# SUBMITTAL SUMMARY REPORT 32452

**PLAN NAME:** BASELINE ROAD INDUSTRIAL

**OCE: Plan Review Revision (DR) v.1**

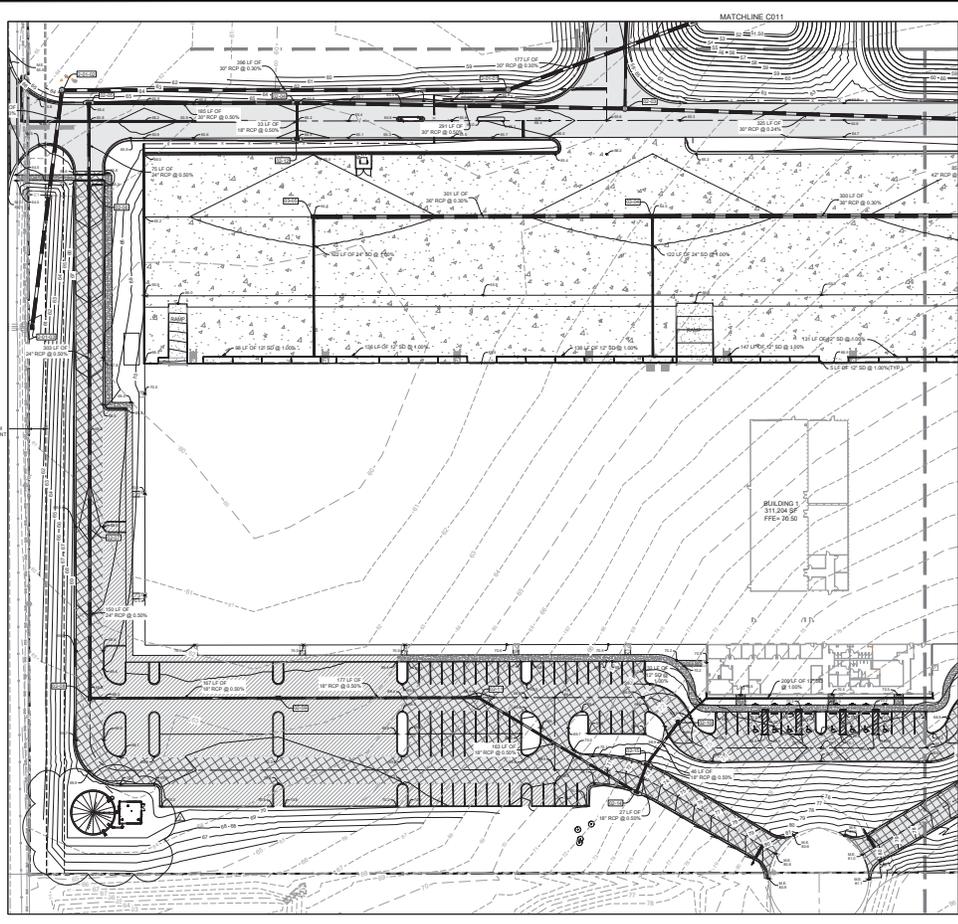
REVIEWER	MARKUP	DATE/TIME	FILE NAME	PG #
Kevin Vickers	5,076.41 sf	12/29/2025 12:13	PM2025-12-15 Civil Plans.pdf	6
